Service Bulletin B0003001 2000-12

Models Effected: Small Frame ZT Riding Mowers.

**Subject:** Caster Wheel Kit.

## CASTER WHEEL KIT INSTRUCTIONS

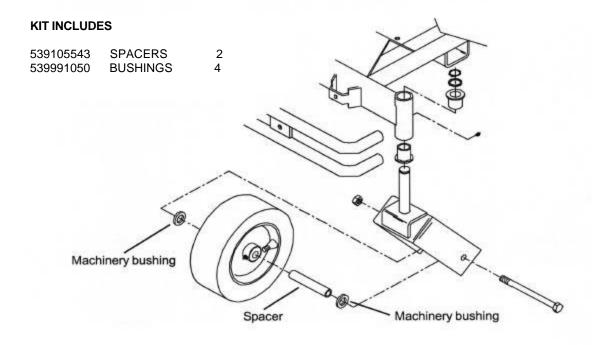
**Service Information:** This caster wheel kit has been developed to prevent the front tire side walls from rubbing on the caster yokes. New machinery bushings, spacers, and illustrated installation instructions are included in the kit.

- 1. Raise the front of machine so caster wheels are off the ground. Be sure to block up machine with jack stands.
- 2. Remove 1/2 x 5 1/2 bolt from caster yoke and wheel.
- 3. Slide wheel assembly out of yoke and remove the old spacer from the wheel.
- Insert the new spacer into the wheel assembly with a machinery bushing on each side of the wheel.
- Reinstall the wheel assembly into the caster yoke. Making sure the machinery bushings are still on the spacer tube and rotate freely. Note: The caster yoke may have to be spread apart slightly to accommodate the new spacer.
- 6. Reinstall the 1/2" bolt and nut through the caster yoke and wheel. Again making sure the machinery bushings are still on the spacer tube and rotate freely. If bushings are not installed properly wheel hub could rub on bushing causing wear to the bushing and the wheel hub.
